CONWAY
HISTORIC DISTRICT COMMISSION
APRIL

CONWAY HISTORIC DISTRICT COMMISSION MEETING

**ROBINSON HISTORIC DISTRICT
CERTIFICATE OF APPROPRIATENESS REVIEW
INTERIOR / EXTERIOR RENOVATIONS
1917 CALDWELL STREET**

OLD CONWAY DESIGN OVERLAY DISTRICT CERTIFICATE OF APPROPRIATENESS REVIEW GORDY RESIDENTIAL OUTBUILDING AND CARPORT

Proposed Carport to Garage Conversion

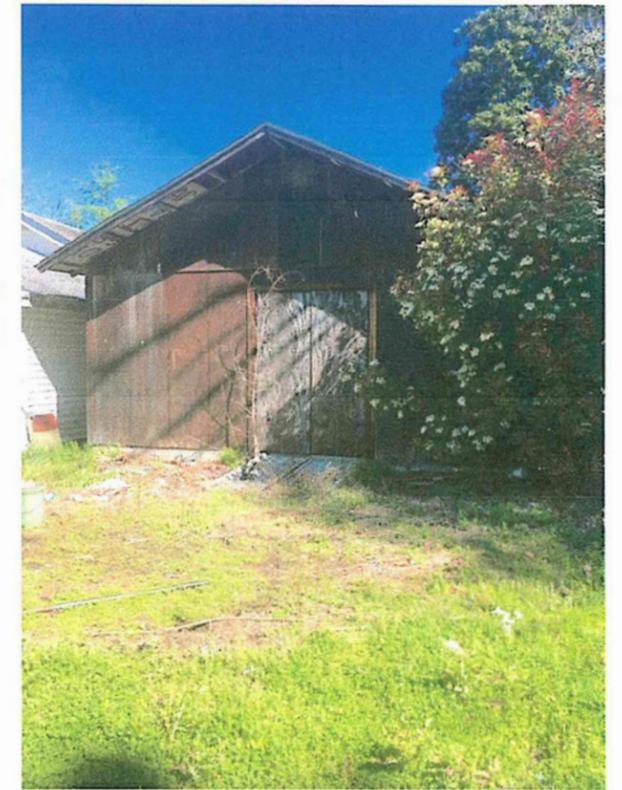
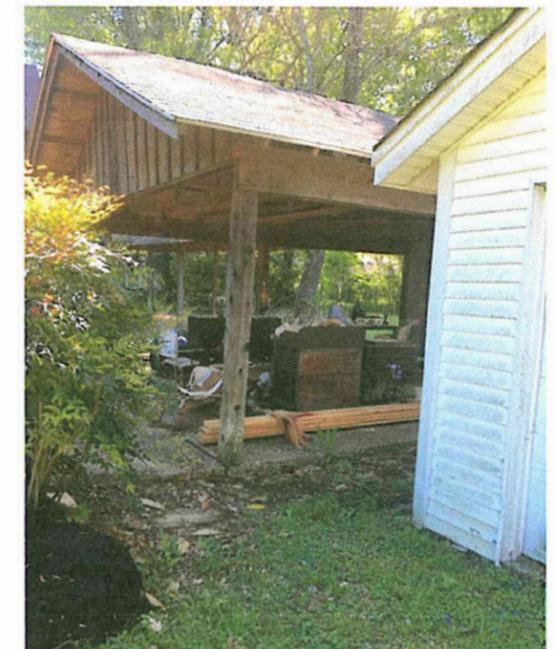
Driveway/Parking/Carport. There is an existing concrete driveway onto the property. The driveway will remain unchanged. The applicant would like to enclose the non-original carport to a garage. There is a non-historic garage adjacent to the carport on the lot abutting to the west.

The carport would be enclosed with board and batten to match the existing house. A carriage style door and peak rafter detail are also proposed.

1. Carport may be remodeled to create an enclosed garage. Garage siding shall be board and batten to match existing residence. Cement board siding shall be used.
2. The non-historic kitchen area picture window may be replaced with approximately 2 foot x 4 foot sash windows to match existing historic windows.
3. Replace existing windows? Possibly allow replacement of non-historic dormer windows?
4. Old board and batten may be replaced with matching cement-board board and batten.
5. The double entry doors may be replaced with new 1/2 glass double doors as proposed.
6. Existing door corbeled brick entry may be straightened to a rectangular opening with brackets as proposed.
7. Asphalt roof may be replaced with in-kind asphalt roof.

Elevations - New Residential Outbuilding

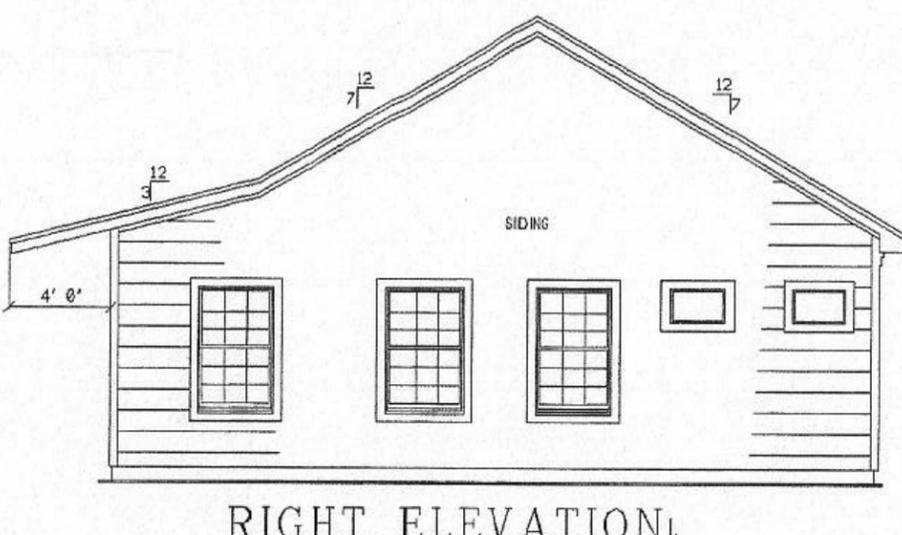
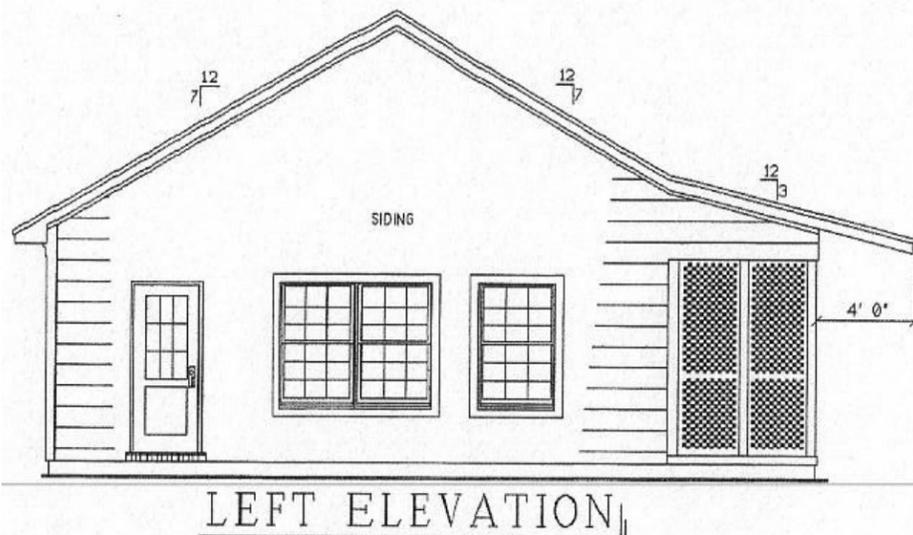
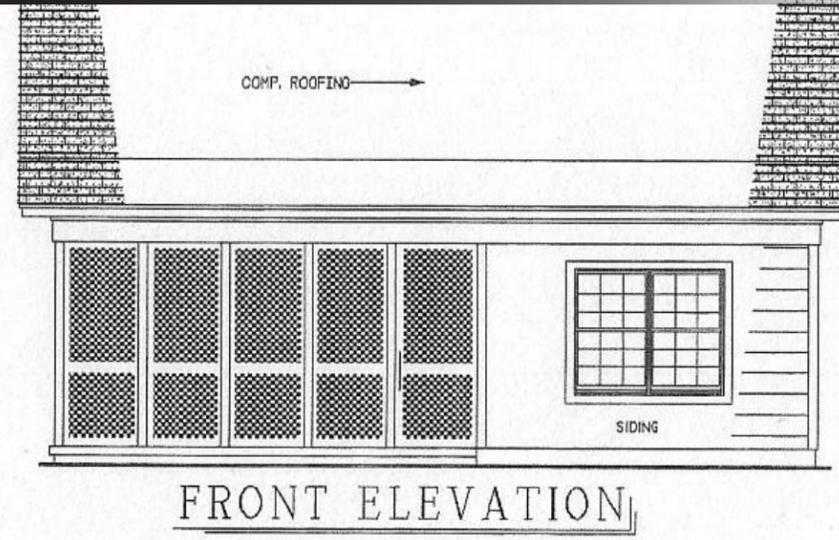
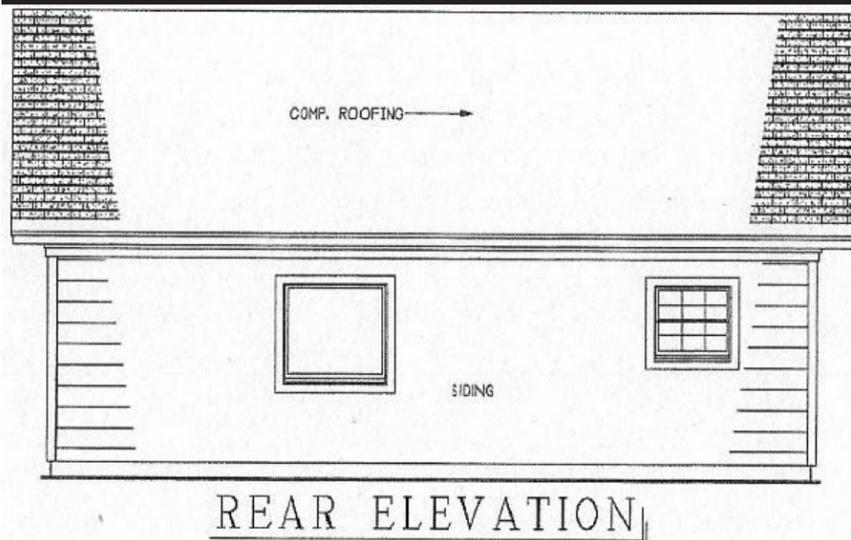
Architectural Details, Siding, and Bricks. Eaves, brackets, dentils, cornices, molding, columns, trim, etc. The outbuilding has minimal detailing. Wide trim is shown around the windows. The minimal level of detailing blends with the primary residence which is a minimal traditional structure. The applicant has not provided the type of siding material. The existing residence appears to have metal or aluminum siding. It is assumed that the applicant would like to use vinyl siding. More information can be obtained at the meeting.

Entries, Porches, and Porticos. Appropriate entry points are provided. Porches are to be a minimum of 6 feet in depth. The front porch shown is small, but 6 feet in depth. Porch column widths are smaller, but are part of a screen porch assembly. Carport columns are not shown. The carport columns should be trimmed to a substantial width such as 6"x 6" or larger.

Doors and windows. The doors and windows shown have muntin dividers creating 9 over 9 windows. Simple one over one windows would be more appropriate than windows with false dividers. There is a large window shown over the bathroom. This is assumed to be some type of non-operable obscured glass window.

1. The outbuilding and carport shall be constructed as shown in submitted plans.
2. The outbuilding and carport setbacks shall be as shown on the submitted site plan.
3. Carport shall be constructed similar to existing garage and residence in style and materials.
4. Carport columns shall be a trimmed out to approximately 6 inches by 6 inches.
5. Floor to ceiling height shall be 9 foot minimum.
6. Siding material? Vinyl siding shall be allowed.
7. Wide trim around windows and doors shall be used as shown.
8. One over one windows may be used in line of false window dividers.
9. HVAC and utility equipment shall be appropriately located at the rear or side of the structure and/or appropriately screened.
10. A 4 foot sidewalk shall be constructed along Davis Street or an in-lieu fee of \$12 per linear foot may be paid (\$940 total).

Elevations

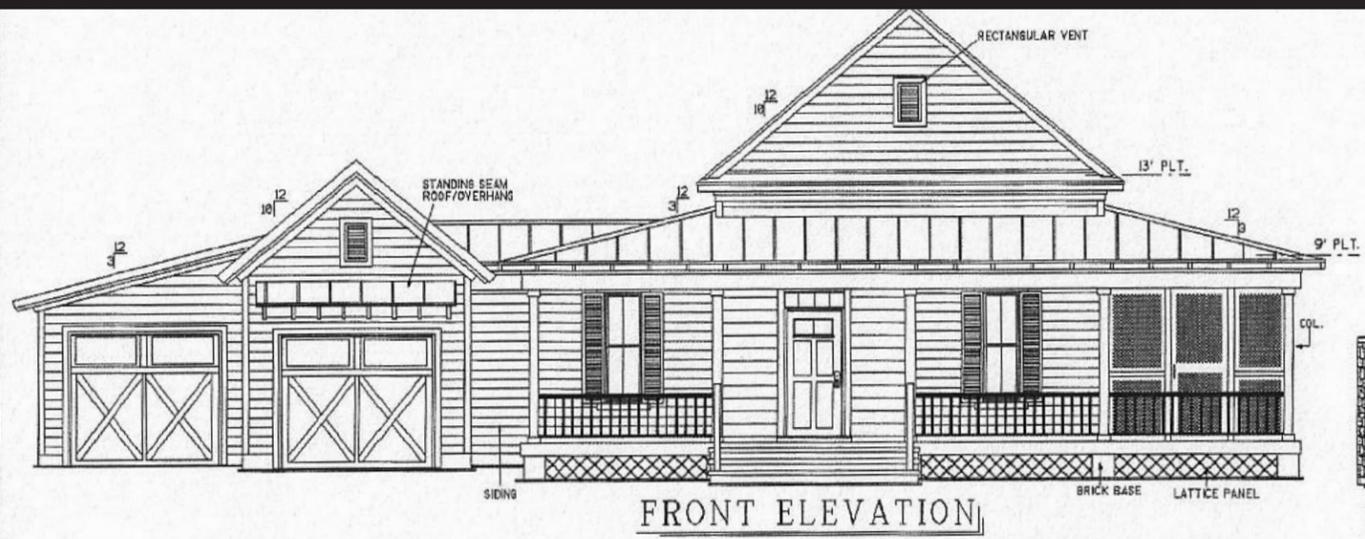
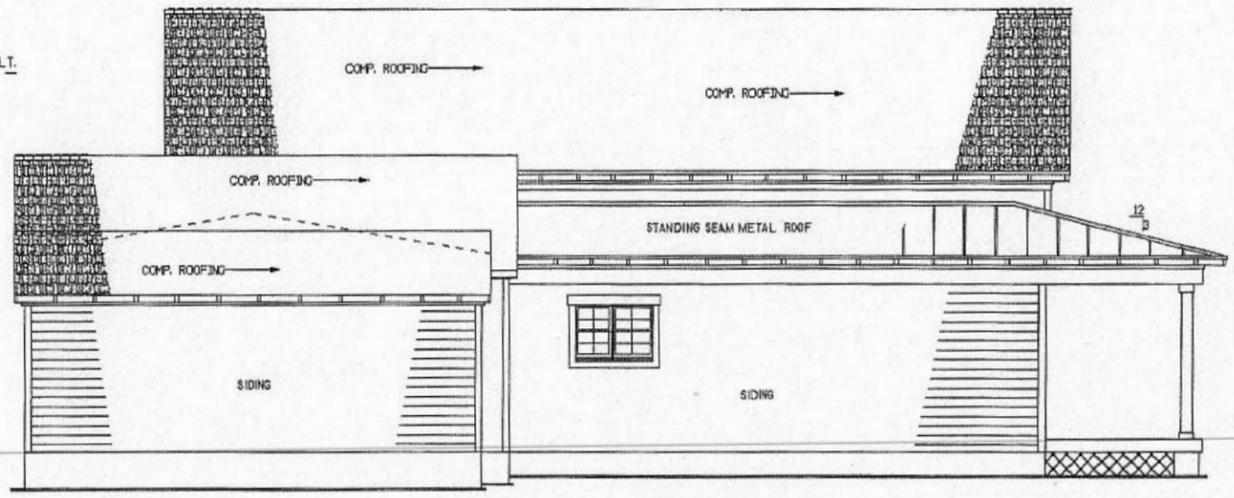
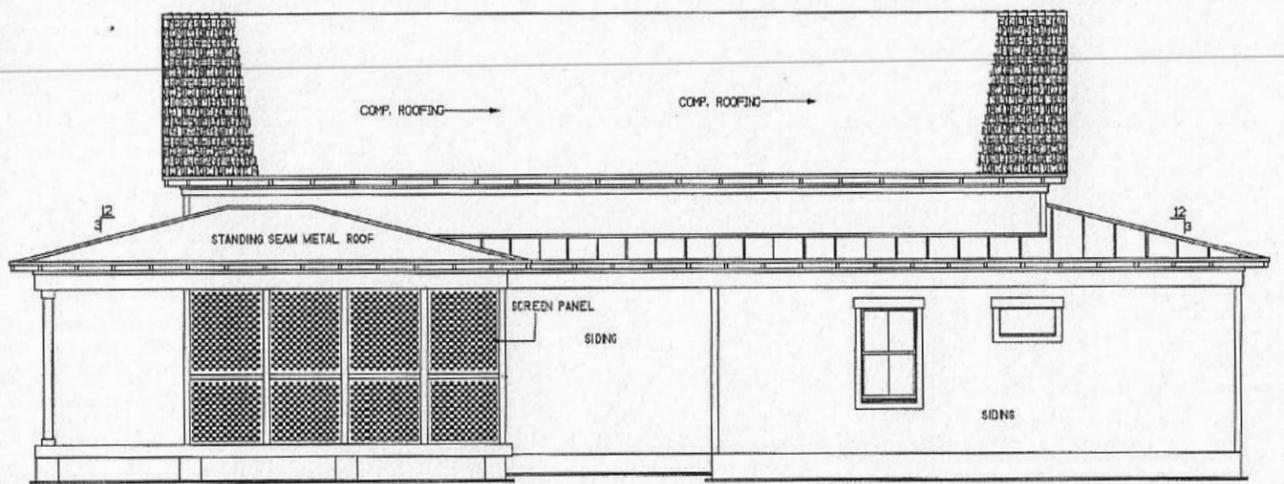
Entries, Porches, and Porticos. Appropriate entry points are provided. Porches are to be a minimum of 6 feet in depth. The front porch shown is shown at around 8 feet in depth. Porch column width may be a bit small in relation to the overall scale. The column width should be a minimum of 8" x 8" final trim dimension.

Doors and Windows. Windows are shown with muntin dividers creating two over two windows. Simple one over one windows would be more appropriate than windows with false dividers.

Architectural Details, Siding, and Bricks. Eaves, brackets, dentils, cornices, molding, columns, trim, etc. The residence has detailing provided through wide door and window trim, open rafter tails, and varying roof materials. These features add traditional detailing. The applicant has not provided the type of siding material. Fiber cement siding is preferred.

1. The residence and driveway shall be constructed as shown in submitted plans.
2. The residence's front setback shall be approximately 30 feet from the McKay pavement or 15 feet from the property line.
3. Porch columns shall be a trimmed out to 8 inch by 8 inch minimum.
4. Floor to ceiling height shall be 9 foot minimum.
5. Siding material?
6. Wide trim around windows and doors, open rather tails, and mixture of roofing shall be used as shown.
7. One over one windows may be used in lieu of false window dividers.
8. HVAC and utility equipment shall be appropriately located at the rear or side of the structure and/or appropriately screened.
9. A 4 foot sidewalk shall be constructed along McKay Avenue or an in-lieu fee of \$696 may be paid.
